Recommendations on reliable via connections

Adding filled zones to via lands

Objective: Ensuring reliable via connections through requirement-compliant design

Figure 9-1 Examples of modified land shapes

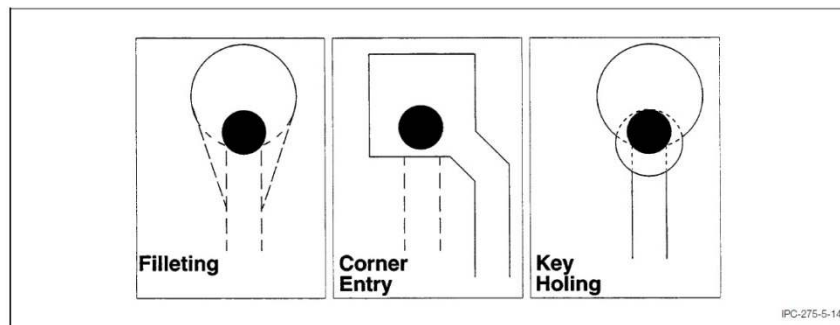
If the design does not provide modified land shapes (e.g. no teardrops) as shown in the example (Fig. 9-1), the rule "≤ 90° hole breakout allowed if the land/ conductor junction is not reduced by more than 20% of the minimum value" should be applied with regard to the annular ring requirement for class 2 products.

Other alternatives such as adjusting the layout or reducing the hole diameter increase process costs and must be agreed between the user and the supplier (AABUS).
